PROPOSAL FOR DRAFT AMENDMENTS TO REGULATION No. 98

(Headlamps with gas-discharge light sources)

Transmitted by the Expert from the Working Party "Brussels 1952" (GTB)

"Figure D
Primary Driving Beam

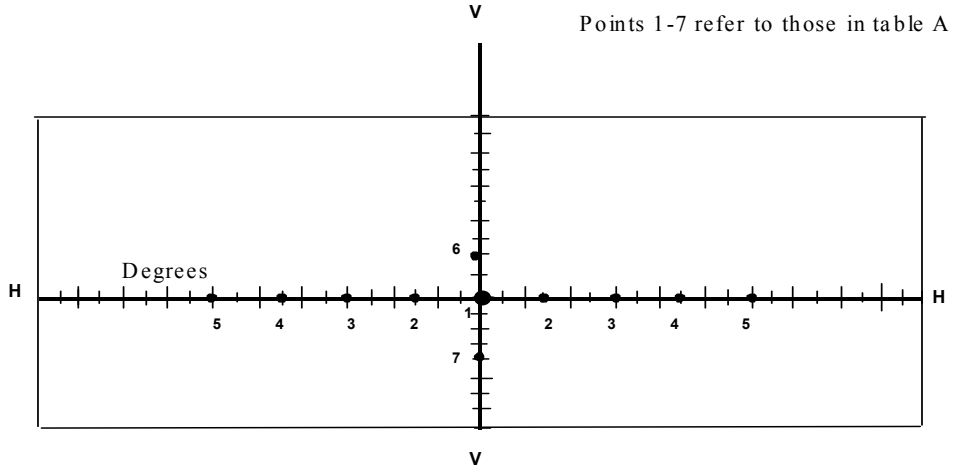
Annex 3, insert at the end figures D and E, to read:

"Table A - Primary driving beam headlamp

Refer to Figure D for details of test point positions
